### NEW INTERNAL LAMP “LOW VOLTAGE”

Dorotea            60cm  
Domodossola    45cm

1 – grounding connection

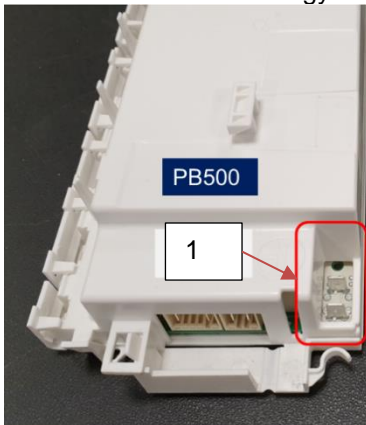
Starting from December 2020 and with the introduction of the new main board PB500 (recognizable by the grounding connection as shown in the picture), the internal lamp is changed from “High Voltage” to “Low Voltage”. It means that the new low voltage lamp is driven by the power board, that permit to avoid current spikes that could overload the power supply.

it also allows to save energy and to align the appliances with the new European regulations and new Energy Label

**With the new PB500 electronics, the interior lamp SWITCH OFF after 10 minutes (if the door remains open).**

“This is normal and not a fault on the machine”

To switch ON the light again:

- Press ON/OFF button
- Close and open the door again.
